**INDEPENDENT ADVISORY
PANEL FOR UNDERGROUND
MINING**

**DENDROBIUM COAL MINE
LONGWALL 19
SUBSIDENCE MANAGEMENT PLAN**

February 2021

Figure 1: High resolution closure line survey data from monitoring of Sandy Creek waterfall associated with extraction of LW7 and LW8 in Area 3A (Figure 9 in Walsh, Mills, et al. (2014))

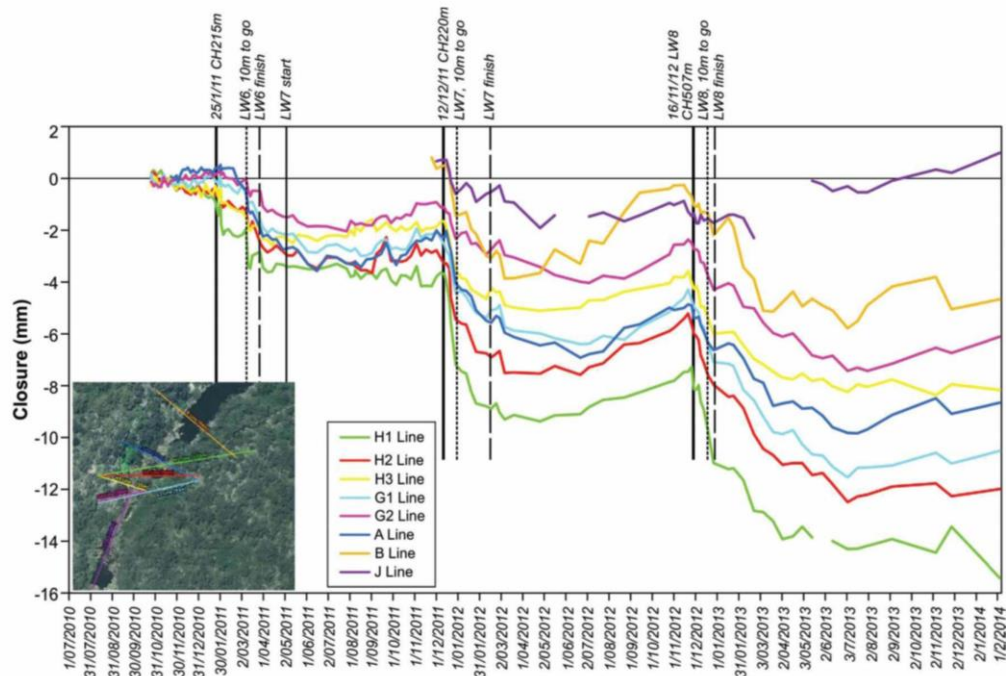
Sandy Creek Waterfall is located 900 m north-east of the commencing end of LW19. The total closure measured at the waterfall, due to the previous mining of LW6 to LW8 in Area 3A, was 14 mm. The predicted incremental closure for Sandy Creek Waterfall, due to the mining of the proposed LW19, is less than 2 mm, which is in the order of survey tolerance and environmental effects.

The approach proposed in the SMP to managing mining induced subsidence effects on Sandy Creek Waterfall prompted a number of questions from the Panel to South32 (IAPUM, 2020). In responding to these, South32 has advised that:

- The H2 Line was surveyed on 8 January 2021 and an additional closure since the previous survey on 18 September 2014 of approximately 4 mm was measured.

- The predicted closure due to the extraction of LW19 has been revised and increased to less than 5 mm.
- *It is extremely difficult to quantify the additional closure capacity of the waterfall as it is dependent on many factors that themselves are difficult to fully quantify....Even if these factors could be quantified, it would still be difficult to quantify the extent to which these factors influence the stability of the waterfall in its natural state or when subjected to mine subsidence effects.*

- Although an incremental increase in predicted closure of less than 5 mm may appear a trivial value in absolute terms, it is significant when regard is had to the amount of closure associated with the cessation of extraction of LW6, LW7 and LW8.
- As a matter of due diligence, the Technical Committee formed under the Sandy Creek Waterfall Management Plan should be engaged in determining the setback distance of LW19 from the waterfall and the appropriateness and robustness of the monitoring plan and associated trigger levels and responses.

1. The Department embrace the proposal of South32, dated 15/1/2021, that the Sandy Creek Waterfall Management Plan be re-established and applied to the extraction of LW19.
2. The starting location of LW19 and the proposed monitoring plan and its associated triggers and responses should take into account the latest field survey results and be endorsed by the Technical Committee previously constituted for the Sandy Creek Waterfall.

Figure 2. Extract from Drawing DEN-01-7783 from the SMP showing the location of Swamp 15a relative to LW19

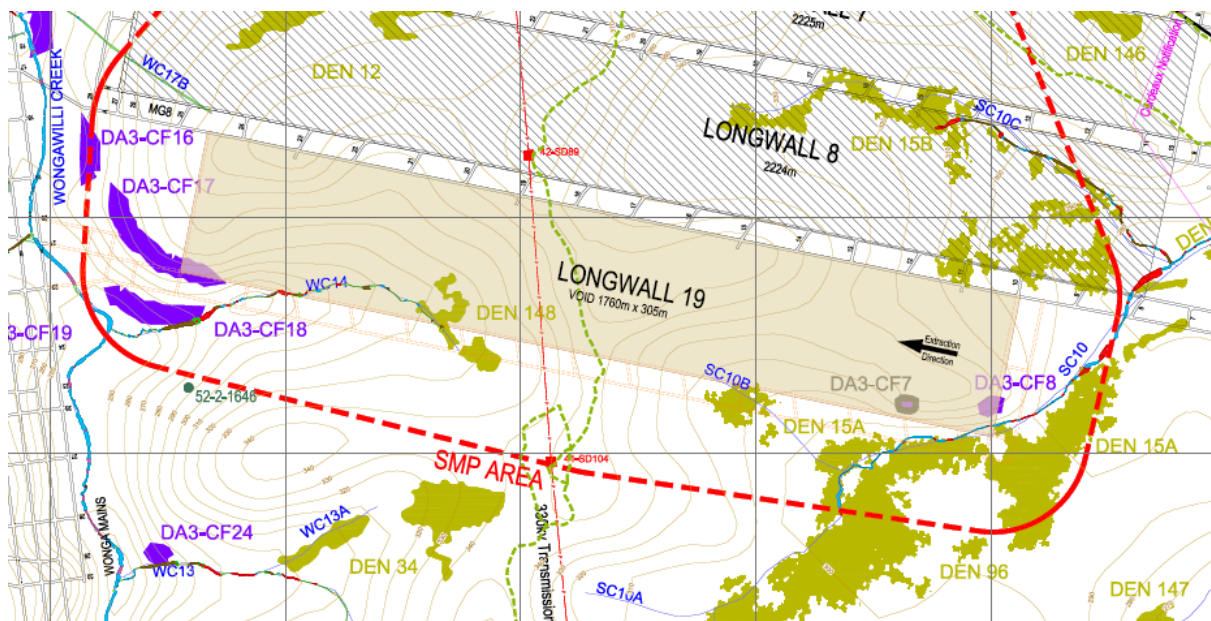
The footprint of Swamp 15a is shown in Figure 2. A significant point of note is that a portion of Swamp 15a is located over the upper reaches of SC10B and abuts and partially overlies the footprint of LW19.³ It has the potential to seriously impact the permissible length or width of LW19 given the Consent Conditions relating to Swamp 15a.

With the present Consent Condition for Swamp 15a, the southern edge of LW19 needs to be offset at least 60 m from the edges of Swamp 15a. This requires either a narrowing or a reduction in the length of the longwall to substantially reduce the likelihood of a change in ecosystem functionality. Monitoring of performance would still be needed. To date, vegetation changes – swamp size; species richness, distribution, composition and diversity; vegetation sub-communities – have been used as surrogates for ecosystem functionality for approvals of mining to date in Dendrobium. The Proponent proposes to continue with this approach (South 32, 2020 - SIMMCP Table 6.1).

With the current longwall layout, the Panel considers it predictable with a high level of certainty that the proposed LW19 will result in changes in ecosystem functionality in parts of

Swamp 15a within 60 m of the longwall. This is based on the significant changes to swamp groundwater levels observed within that distance at other swamps in the Dendrobium mining area (Watershed HydroGeo, 2019). The Panel notes that 7 or 9 % of the swamp would be within 60 m of the proposed longwall (both figures are noted in SMP Section 5.3.3).

This layout would certainly fail to meet the performance measure required under Condition 5. Regarding the proposed groundwater performance indicators in Table 1.2 of the SIMMCP, the Level 1 indicator would almost certainly be surpassed if any of the monitoring points were within the 60 m threshold, while the Level 2 and 3 indicators are unlikely to be surpassed as they require increasing proportions of the monitoring points to be affected. The other indicators related to ecosystem functionality may not be surpassed on a useful time-scale for reasons covered previously.

- As a minimum requirement to meet Condition 5 regarding ecosystem functionality of Swamp 15a, LW19 should be set back at least 60 m from all edges of Swamp 15a.
